From: Scala, Mary Joy
Sent: Monday, August 24, 2015 10:57 AM
To: Stakem, Trip
Subject: BAR Action – August 18, 2015- 511 1st Street N.

BAR 15-08-02
511 1st Street N.
Tax Parcel 330001205
City of Charlottesville, Owner/ Public Utilities, Trip Stakem, Applicant
Above ground water vault

**CITY OF CHARLOTTESVILLE
BOARD OF ARCHITECTURAL REVIEW
STAFF REPORT
August 18, 2015**

BAR 15-08-05
511 1st Street N
Tax Parcel 330001205
City of Charlottesville, Owner/ Public Utilities, Applicant
Above ground water meter vault

CITY STANDARDS	
3" METER VAULT	
511 N. 1ST STREET	
CURRENT CONDITION	
SCALE: N.T.S.	STANDARD NUMBER:

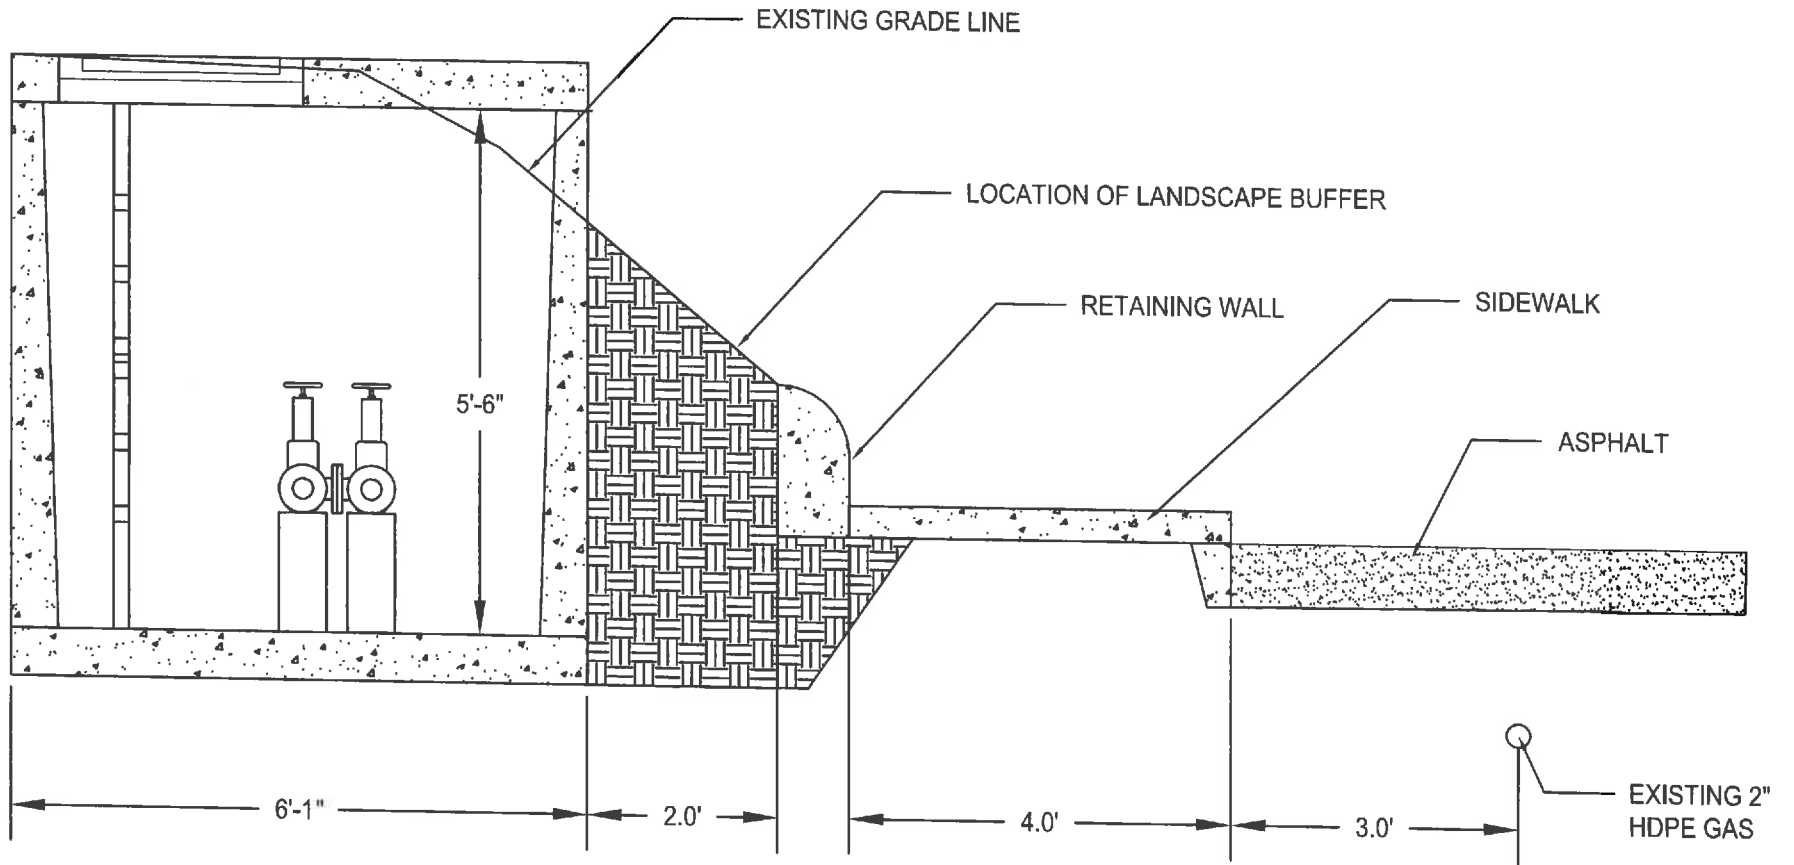
Second, the unsightly utility is located in the front yard of a property in the North Downtown ADC district. A private property owner would not be permitted to install a mechanical unit or accessory structure in the front yard. Such units are permitted only in the side or rear yard with minimum five foot setback and specified screening.

In order to make this installation comply, it would have to be placed flush with the ground. Leaving it above ground would not conform with setback requirements, and would be very difficult to screen. This mulched area was originally intended as a landscaped area to help screen the parking lot. Even if the vault is placed flush, having a large underground vault there precludes landscaping in that immediate area.

CITY STANDARDS	
3" METER VAULT	
511 N. 1ST STREET	
OPTION 2 - LOWER LID	
SCALE: N.T.S.	STANDARD NUMBER:

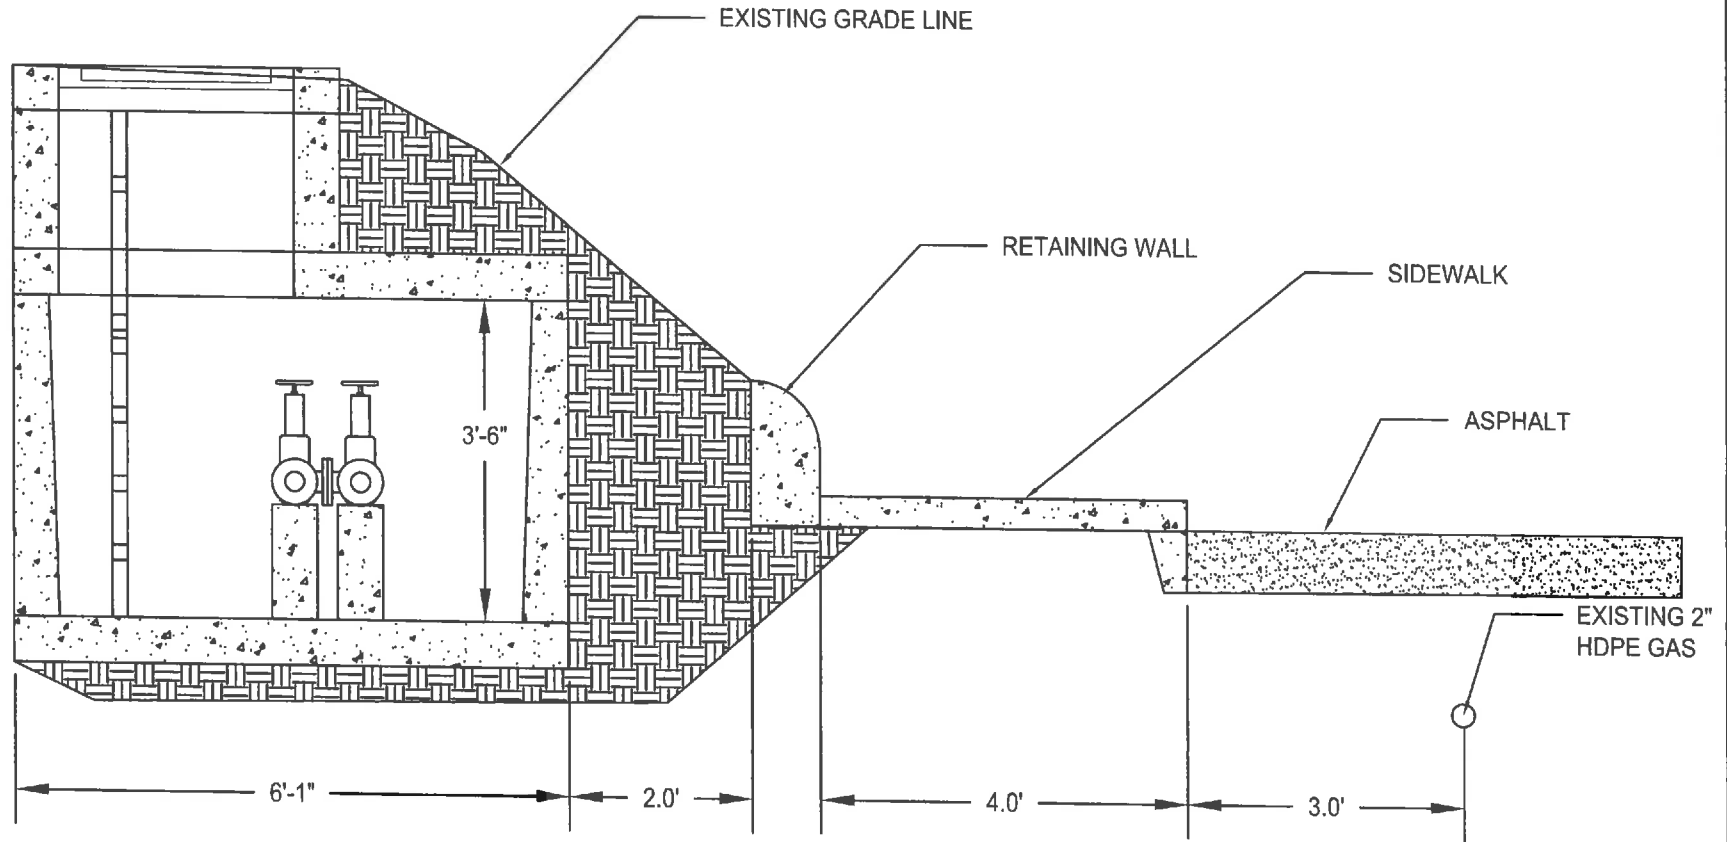
Option 2 is an inefficient solution that would not produce a compatible aboveground solution in harmony with the historic landscape, and, according to the application narrative, would not promote infrastructure efficiency.

I strongly oppose *Option 2. Lowering the top of the existing structure.* For the following negative impacts cited by Mr. Stakem on the BAR Certificate of Appropriateness Application:

- *“The potential to void manufacturer’s warranty for the vault”* This seems imprudent and careless with taxpayer funds and inviting future trouble and expense.
- *“Maintenance will become more difficult due to reduced head space inside the vault.”* This invites future problems for city workers and additional expense.
- *“Medium to high cost”.* Misuse of funds.

- BOTTOM OF VAULT AND PIPING WILL REMAIN IN CURRENT LOCATION.
- TOP WILL BE REMOVED. 24" WILL BE CUT FROM EACH WALL. A CUSTOM TOP WITH RISER STACK ENTRANCE WILL BE INSTALLED.
- NO WATER DISRUPTION IS NECESSARY.

3" METER VAULT
511 N. 1ST STREET
OPTION 3 - LOWER VAULT

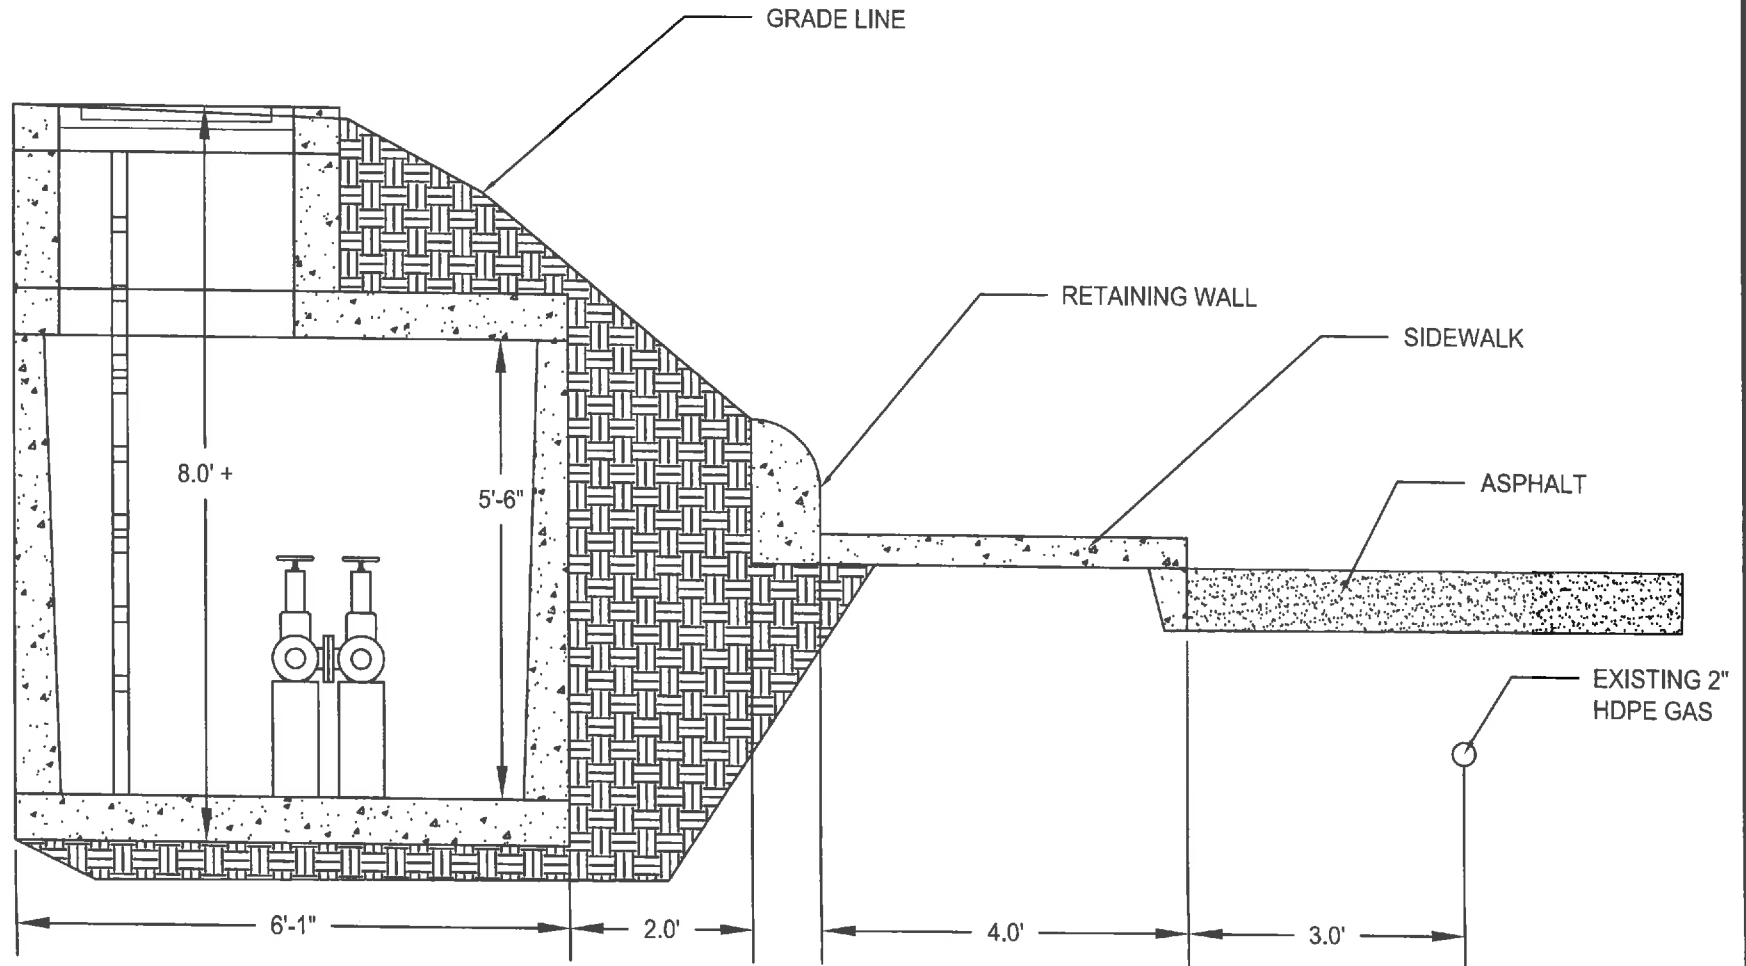
we ask that you only consider Option 3.

I **strongly oppose** *Option 3. Lower the entire vault.* For the following negative impacts cited by Mr. Stakem on the BAR Certificate of Appropriateness Application:

- *"Disruption of water service to Towers for the duration of construction"*
- *"Potential safety hazards due to the additional depth of excavated trench"* Why would the city want to create a known hazard?
- *"Highest cost"* As a taxpayer with 5 properties in the city, I am concerned that taxpayer funds are not appropriately used.

Option 3. **Lowering the Entire Vault.** The disruption of water service to the building is strongly opposed.

- ENTIRE VAULT WILL BE REMOVED. 24" ADDITIONAL EXCAVATION UNDER THE VAULT. VAULT WILL BE REINSTALLED AT NEW GRADE.
- TOP WILL BE REMOVED. A CUSTOM TOP WITH RISER STACK ENTRANCE WILL BE INSTALLED.
- 10-12 HOUR WATER DISRUPTION FOR TOWERS BUILDING IS NECESSARY.
